PRODUCT UPDATE

Number: #119
By: S.Lassen, Applications Engineering Dept.
Date: May 29, 2013

PCA.0S/PSA.0S Now with Anti-Rotation
PCP.0S/PSP.0S Becomes Obsolete

Details of Change:

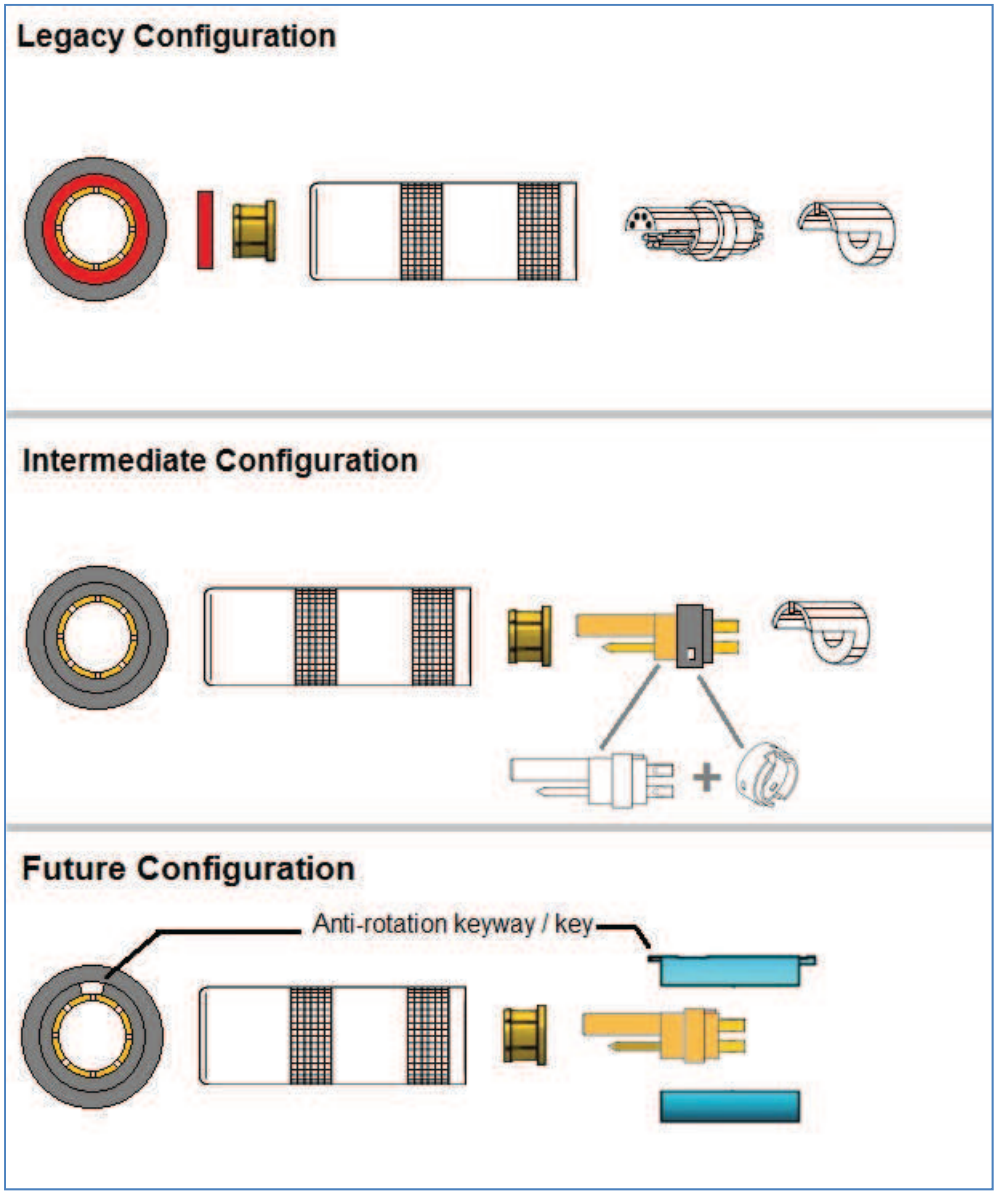
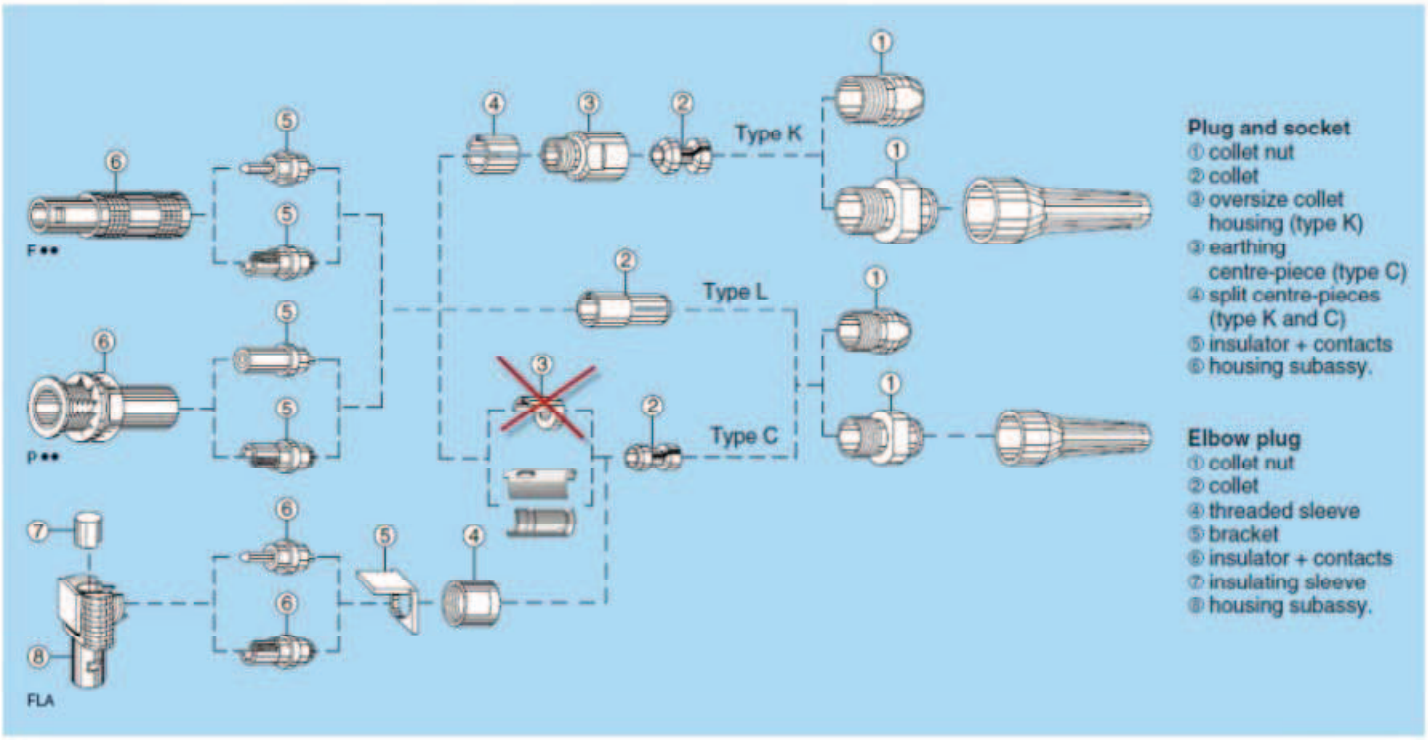
- The inner pieces of the **0S Series** will have a system of keyed components for enhanced anti-rotation characteristics. Anti-rotation models such as PCP and PSP will be phased out and become standard with PCA and PSA models.

- There will be a keyway added to the inside of the receptacle. This new keyway will take advantage of the new inserts and keyed split mid-pieces which will have keys similar to the B Series. The C type collets will also have a keyway to align with the split mid-pieces.

Note: *Type K and L collets will continue to use the single mid-piece /collet design with the intermediate insert configuration, whereas Type C collets for will be shipped with split mid-pieces and corresponding inserts without metal band.*
